Access Compliance Report Public Rights-of-Way (Curb Ramps)

Main Street: MCFADDEN_AVE		Cross Street: BEACH_BLVD		Location:	SE
ADA ID: RPRK211005150221	Ramp Type:Type 1 - Perpendicular Diagonal Initial Pass/Fail: Fail		Overall Compliance: No	Severity Score:	16
Codes/Mitigation Info/Possible Solution			Field Measurements/Component Compliance

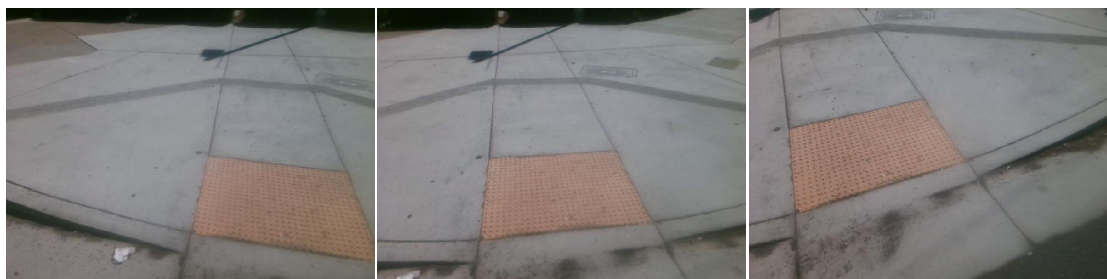
R304.2.2, R304.5.3, STD 1115

Compliance	Description	Data	Compliance	Description	Data
N/A	Ramp Length (in)	106	N/A	Flare Type LT	
Yes	Ramp Width (in)	48			N/A
No	Ramp Run Slope (%)	11.5	N/A	Flare Slope LT (%)	N/A
No	Ramp Cross Slope (%)	2.7	N/A	Flare Traversable LT	N/A
N/A	Landing Present	N/A	N/A	Flare Type RT	
N/A	Landing Length (in)	N/A			N/A
N/A	Landing Width (in)	N/A	N/A	Flare Slope RT (%)	N/A
N/A	Landing Run Slope (%)	N/A	N/A	Flare Traversable RT	N/A
N/A	Landing Cross Slope (%)	N/A	N/A	DWS Provided	N/A
N/A	Landing Movement Obstructed?	N/A	N/A	DWS Contrast	N/A
	Landing Movement Type	N/A	N/A	DWS Length (in)	N/A
N/A	Landing Shared	N/A	N/A	DWS Full Width	N/A
N/A	Clear Space	Yes	N/A	DWS Offset Left (in)	N/A
N/A	Clear Space To Crosswalk (in)	48	N/A	DWS Offset Right (in)	N/A
N/A	Marked Crosswalk 1	Yes	N/A	Marked Crosswalk 2	Yes
	Crossing 1 Direction	N		Crossing 2 Direction	W
	Marked Crosswalk 1 Width (in)	140		Marked Crosswalk 2 Width (in)	140

Remove & Replace Curb Ramp With Two New Directional Ramps or Equivalent. Restripe Crosswalk.
